UNITED STATES PATENT AND TRADEMARK OFFICE

Office Action Summary

09/653,527

BEREZIN ET AL.

9. The following figure includes the labels that will be used in the Kuroda rejections under 35 U.S.C. 102 and 103:

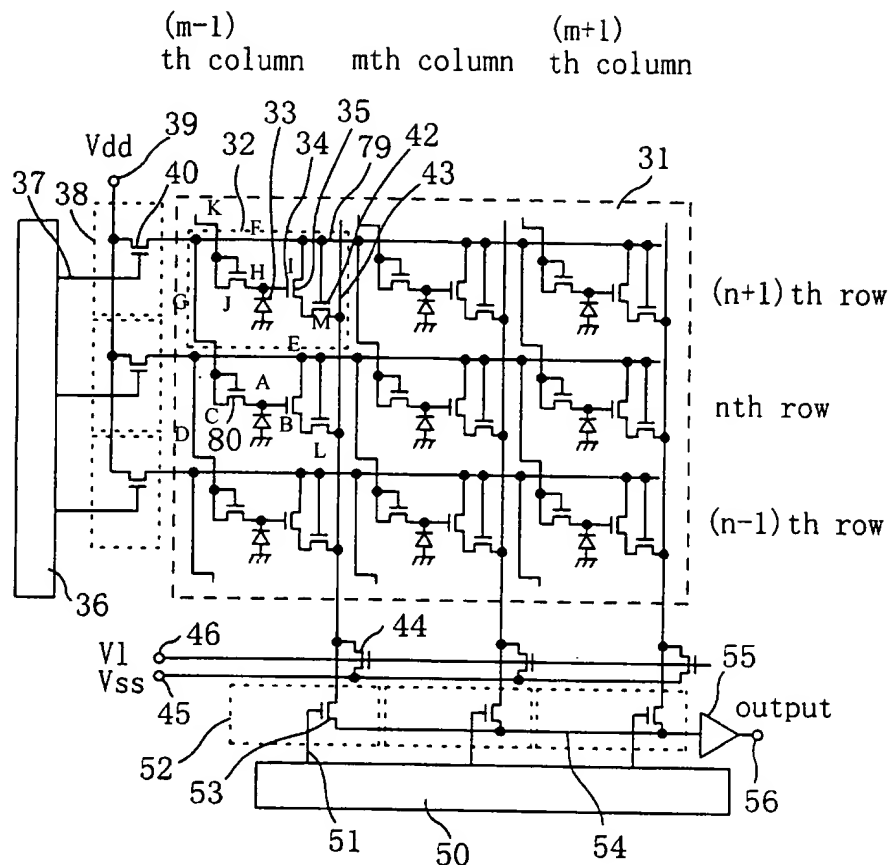
10. Claims 22-⁻²⁸~~25~~ are rejected under 35 U.S.C. 102(e) as being anticipated by Kuroda (U.S. Patent No. 6,512,543).

Regarding **claim 22**, Kuroda discloses an image sensor, comprising:

a first pixel (D), said first pixel comprising a first photoreceptor (A), a first follower transistor (B; see column 6, lines 57-58) having a gate connected to said first photoreceptor, a drain of said first follower transistor connected to a first line (E), and a first reset transistor (C; see column 9, lines 19-20), a drain of said first reset transistor connected to a second line (F); and

a second pixel (G), said second pixel comprising a second photoreceptor (H), a second follower transistor (I) having a gate connected to said second photoreceptor, a drain of said second follower transistor connected to said second line (F), and a second reset transistor (J), a drain of said second reset transistor connected to a third line (K).

said first, second, and third lines are power supply lines (power is supplied from Vdd via row-driving transistors 40).

said first, second, and third lines are connected to a same power supply (power is supplied from Vdd via row-driving transistors 40).

said first pixel further comprises a first select transistor (L) connected to said first follower transistor, said second pixel further comprises a second select transistor (M) connected to said second follower transistor.

said second select transistor and said first reset transistor each have a gate connected to a first reset/select line (F).

a gate of said first selected transistor is connected to a second reset/select line (E).

a gate of said second reset transistor is connected to a third reset/select line

(K).

13. Claims 7, 11, and 12 are rejected under 35 U.S.C. 103(a) as being unpatentable over Kuroda.

a plurality of pixels (D, G, etc.) formed of transistors (B, C, I, J, L, M, etc.), each pixel associated with accepting a pixel of an image, and each pixel comprising:

a photoreceptor (A and H) therein,

an in-pixel follower transistor (B and I) connected to said photoreceptor,

an in pixel select transistor (L and M; see column 9, lines 50-51) connected to said follower transistor,

and an in pixel reset transistor (C and J; see column 6, lines 57-58) which controls applying a reset level;

a first bias line (E) providing power to at least one of said transistors (B) for a first pixel (D); and

a second bias line (F) providing power to another of said transistors (C) different than said one of said transistors of said first pixel, such that said one and said another transistors are separately powered by separate bias lines;

wherein said second bias line (F) is connected commonly to a first plurality of follower transistors (I) in a first row of said pixels (G) and a second plurality of reset transistors (C) in a second row of pixels (D) different than said first row of pixels.

said photoreceptor (A) is connected between a reset transistor (C) and a follower transistor (B).

a dynamic mode read out transistor (selected row driving transistor 40; column 9, line 41) associated with at least one of said bias lines, and allowing said at least one bias line to be active for only a part of a frame period (see chart 66 in Figure 5 and column 9, lines 36-38).
